DNFSB SEISMIC CONCERNS FOR LOW ACTIVITY WASTE/HIGH LEVEL WASTE BASEMAT CONSTRUCTION

Definition, Status, and Recommendations (6-29-02)

July 1, 2002

U.S. Department of Energy
Office of Safety Regulation
P.O. Box 450, H6-60
Richland, Washington

Figure 1. Comparison of mean hazard curves from the Yakima Folds at the 200 East Area for original and modified sets of probabilities of activity.

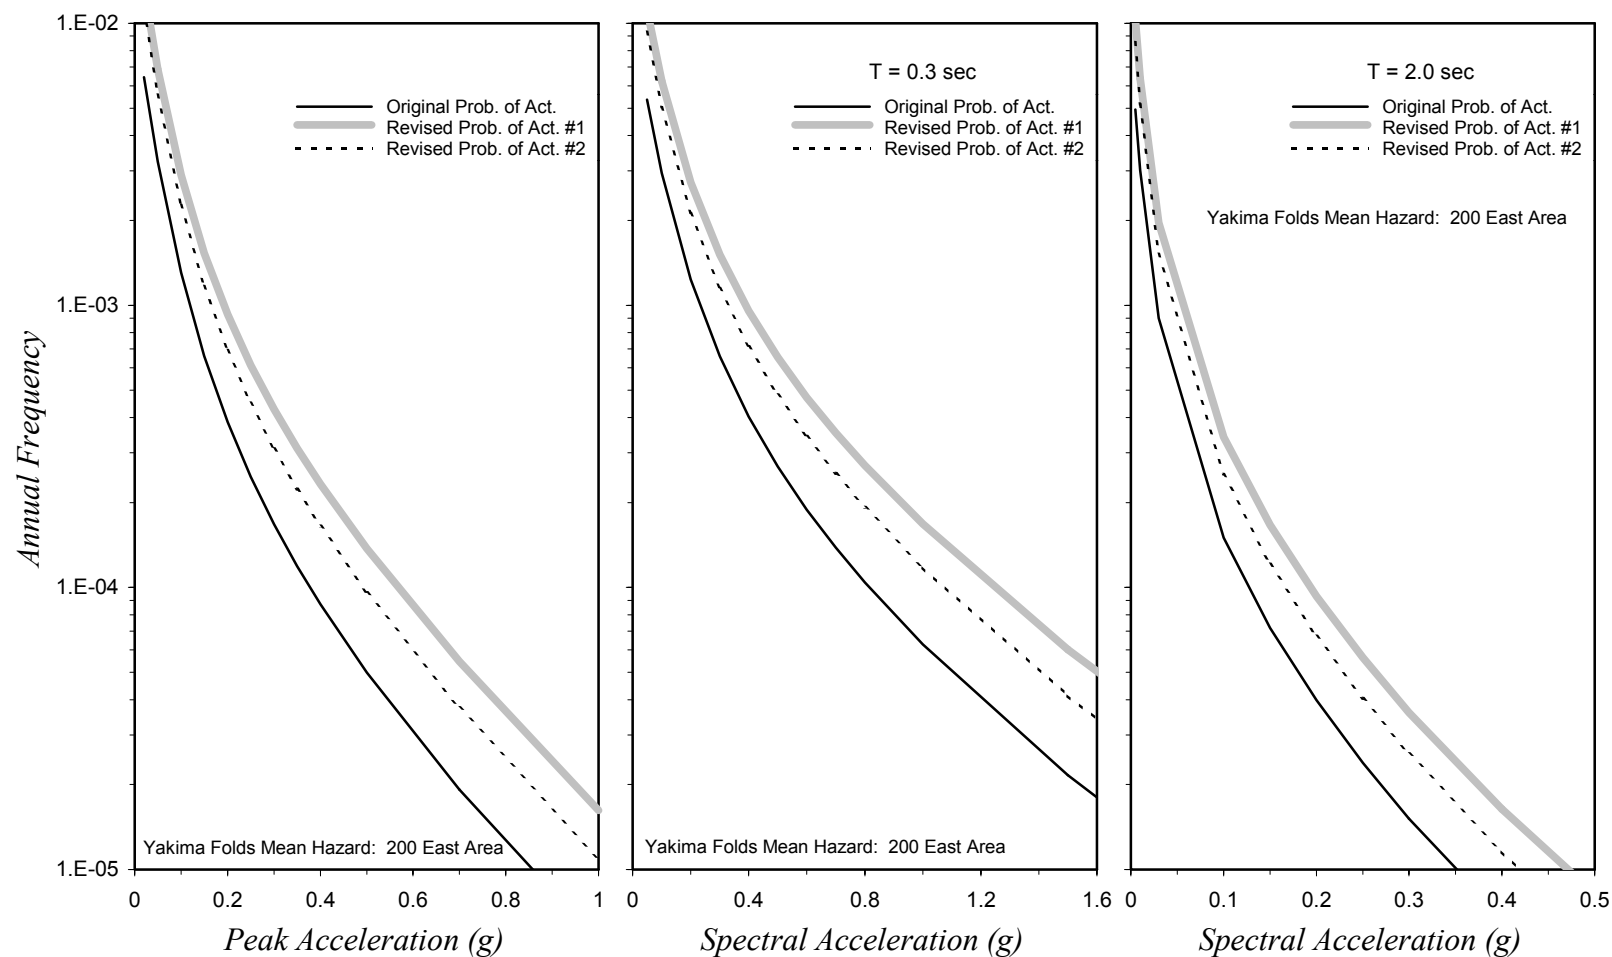
- 1b. Following the June 5, 2002, meeting, the Staff requested a calculation of the effect on the peak ground acceleration if the local anticlines were assumed to have greater activities than assumed in the current Hanford (and WTP) seismic design basis. (The requested parameters are shown in Appendix B.)**

Figure 1 indicates the change in the composite Yakima Fold’s hazard curve by comparing the original hazard curve with those using the two sets of modified probabilities of activity. The readily available hazard curves for three spectral ordinates – PGA, 0.3 sec, and 2.0 sec – are indicated.

Anticline Activity Reparameterization Recommendation: None. The recalculation requested has been started. The calculations performed do not indicate any unusual sensitivity of the calculated ground acceleration to assumptions regarding the probability of activity of anticlines. The complete data set requested will be provided by July 8, 2002. The probability of activity of anticlines that is appropriate to use is the set chosen in the Hanford (and WTP) seismic design basis, as discussed in Item 1a above.

Figure 2 Comparison of total mean hazard curves at the 200 East Area for original and modified sets of probabilities of activity.

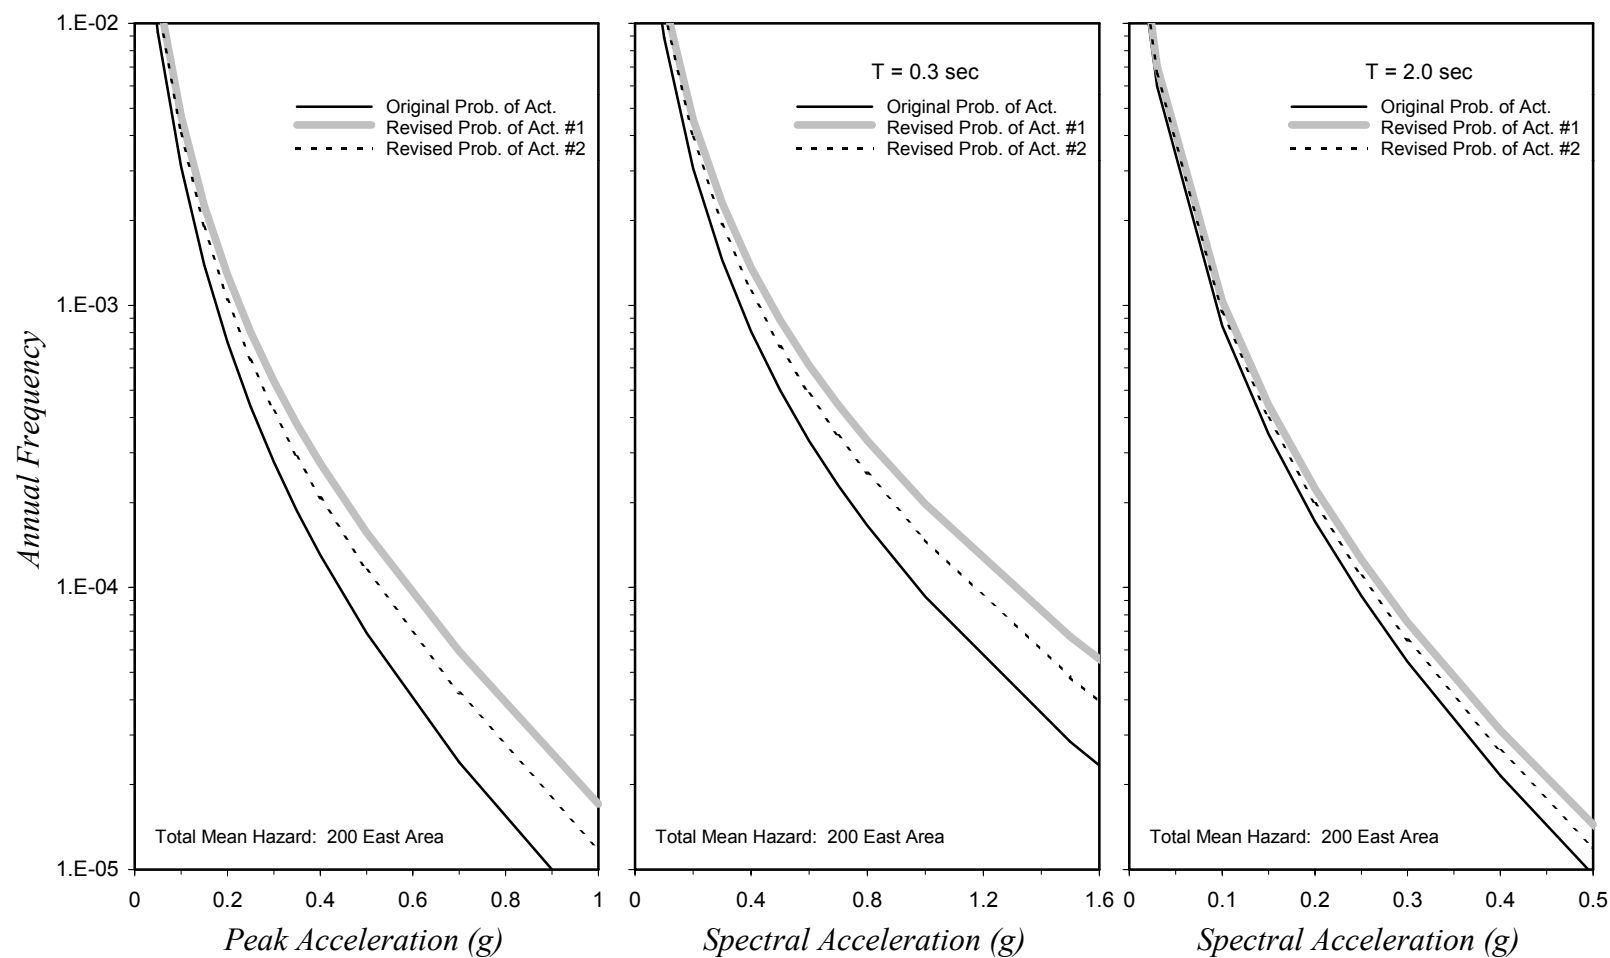
Figure 2 is similar to Figure 1 except the total hazard curves are presented.

Figure 3. Comparison of Geomatrix 2000- and 2500-year motions for 200-East Area with DBE and IBC/USGS

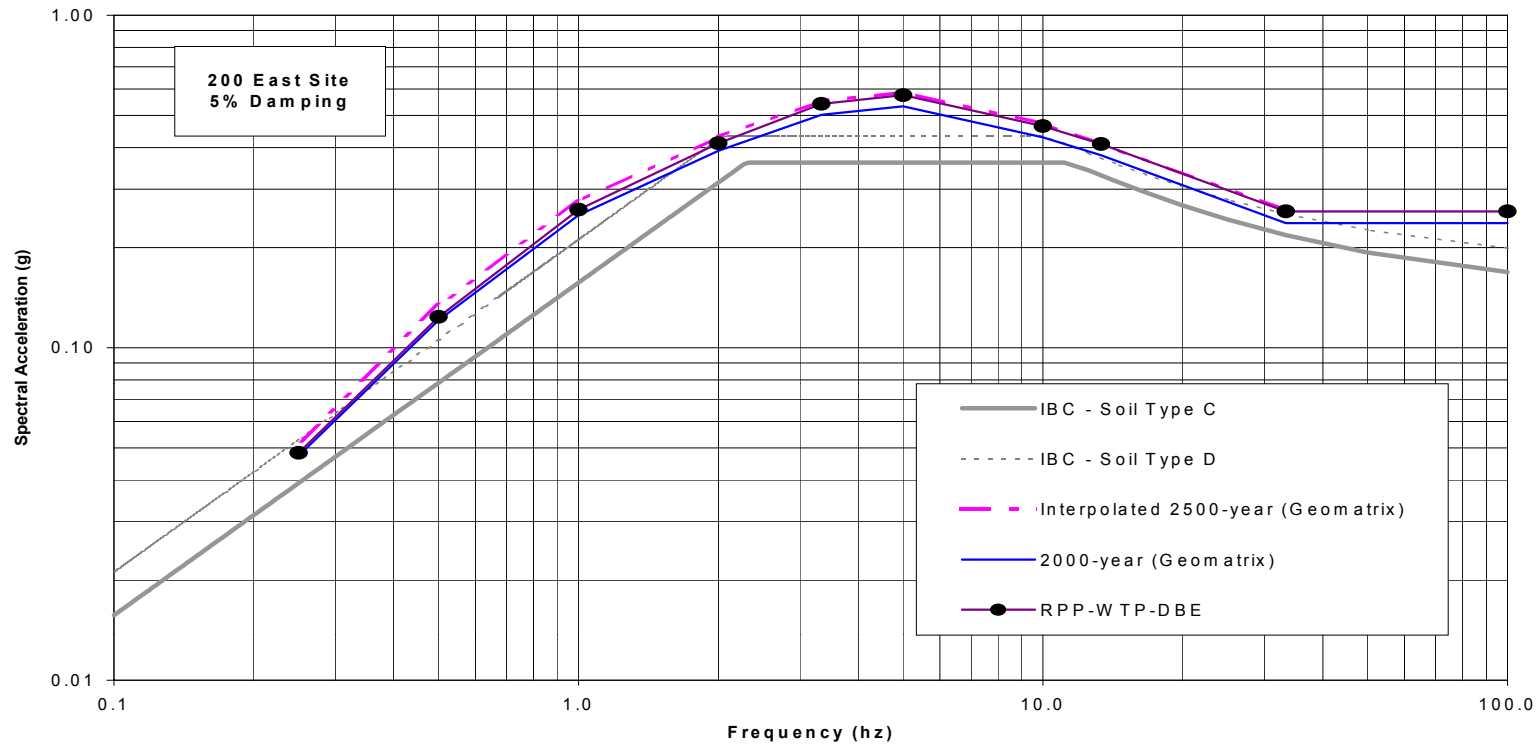
- The Geomatrix report was subjected to a formal and informal peer review by members of the geotechnical community.
 - The US Geological Survey's (USGS) seismic hazard assessment's 2500-year ground motion compares favorably with this study (see figure 3 at end of section).

The OSR should not change the approved Hanford and WTP design basis peak ground acceleration and associated spectra given the strong preponderance of expert opinion that these criteria are appropriate for this location.
